RE: 10-ZN-2005#2
Marriott Springhill Suites Hotel
209Y4 (Key Code)

The Planning & Development Services Division has completed the review of the above referenced development application submitted on 9/9/19. The following **1st Review Comments** represent the review performed by our team, and is intended to provide you with guidance for compliance with city codes, policies, and guidelines related to this application.

Applicant 1st Submittal, South Elevation:

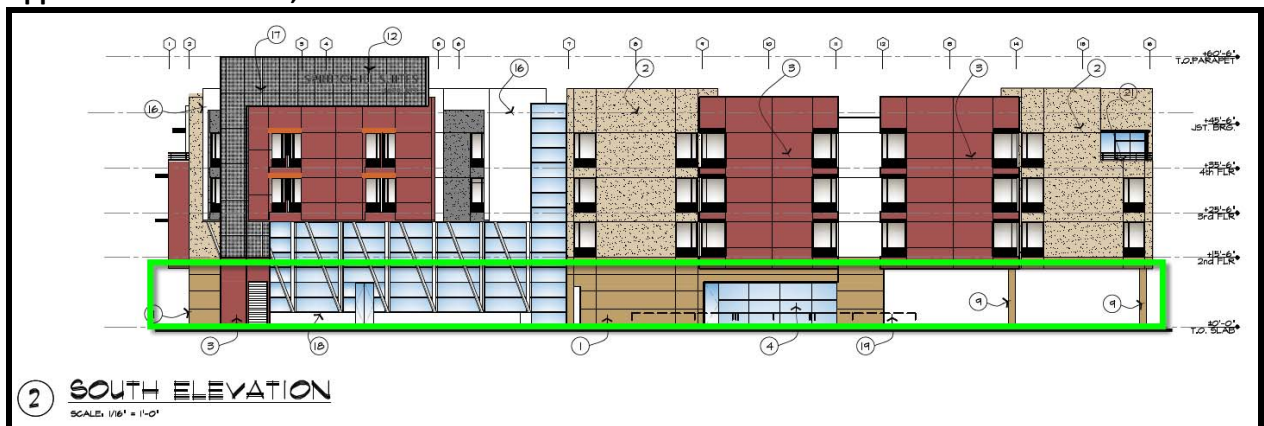
5. The Old Town Scottsdale Urban Design & Architectural Guidelines recommend that new development be compatible and complementary to existing development (Guideline 8) – to the extent of ensuring a balance between new design elements and existing architectural features and materials within the context area. With a resubmittal, consider incorporating some of the design elements established by Optima Sonoran Village, such as open-air podium and/or glass banding along the ground level along Camelback Road (see graphics, below).
